15 MCGRATH HIGHWAY

SUPPLEMENTAL SUBMISSION TO PLANNING BOARD | 02.10.2022

PLANNING BOARD COMMENTS 02.03.2022

BUILDING DESIGN | FACADE ARTICULATION

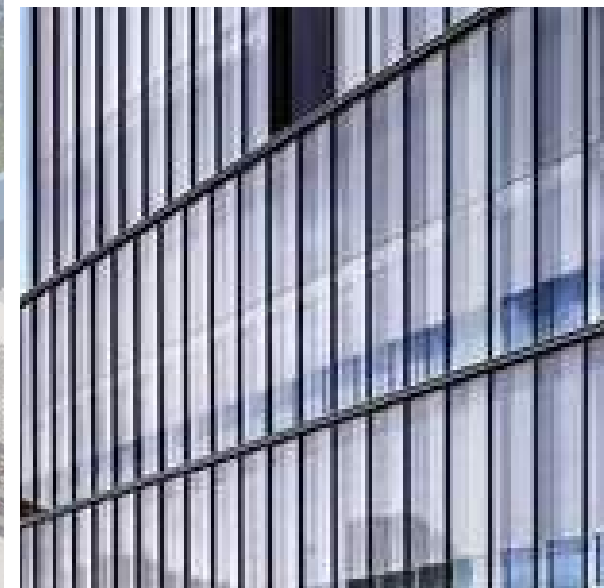
- CONCERN THAT NORTHEAST FACADE NEEDS MORE ARTICULATION
- ADDRESS THE COMMUNITY PATH IN RELATIONSHIP TO THE BUILDING AND LANDSCAPING

STAGGERED METAL PANELS BREAK DOWN SCALE OF FACADE

FINS PROVIDE DEPTH AND RYTHMN TO FACADE WHILE ADDING WARMERTONES TO THE FACADE.

GLASS REVEAL AND FRAME CREATE PAUSE IN THE BUILDING BREAKING DOWN THE MASSING.
